CERTIFICATE OF APPROPRIATENESS

Property: 201 w 15TH Street, Tracts 10, 11, & 12, Block 142, Houston Heights Subdivision. The property includes a historic 4,606 square foot, two-story wood frame single-family residence and detached garage situated on a 13,200 square foot corner lot.

Proposal: Alteration – Construct a rear two-story addition to a two-story residence. The addition will infill the rear northwest corner and will measure 4’-6” wide, 15’-1” deep, and 23’-11” in height.

EAST SIDE ELEVATION FACING YALE STREET

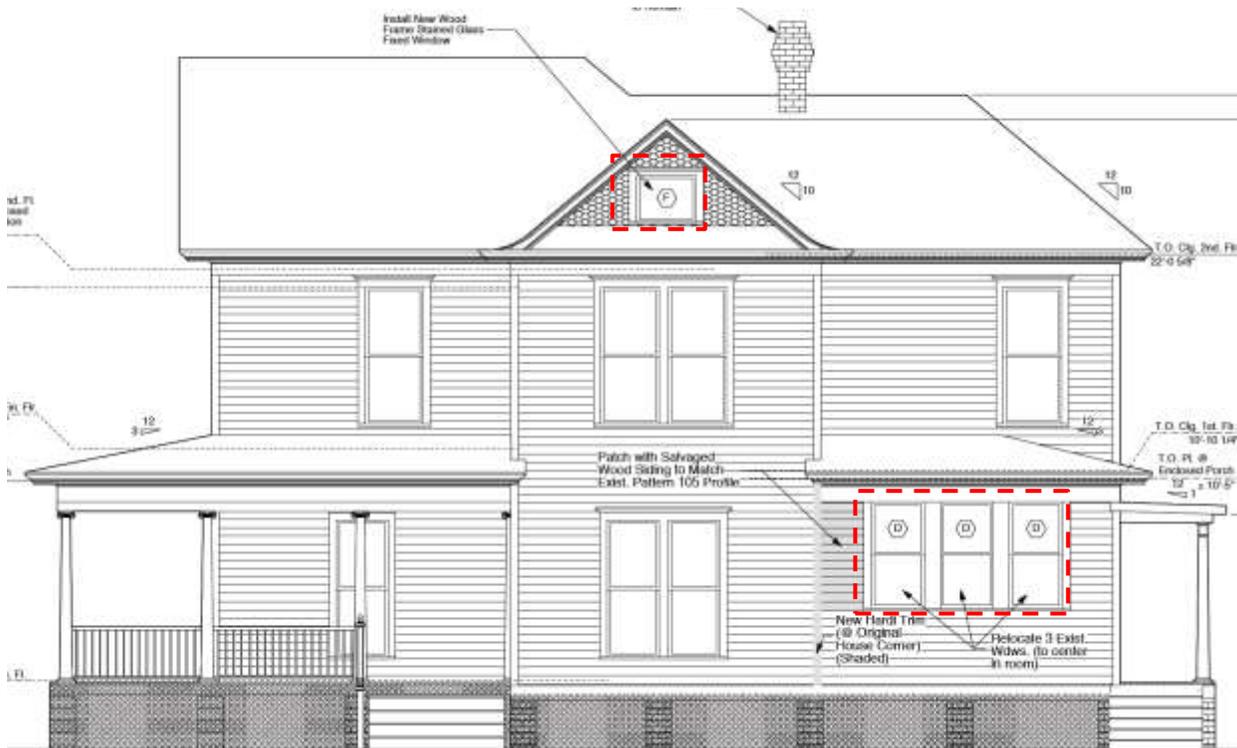
I SUPPORT the granting of a Certificate of Appropriateness for this application with the understanding that the window relocation proposed on the east elevation is in an area that is not part of the original structure (an enclosed porch) and therefore, the existing window location is not historic. The proposed addition on the west elevation is acceptable as it is located at the rear of the existing structure, not visible from a street and is intended to solve a doorway to nowhere issue.
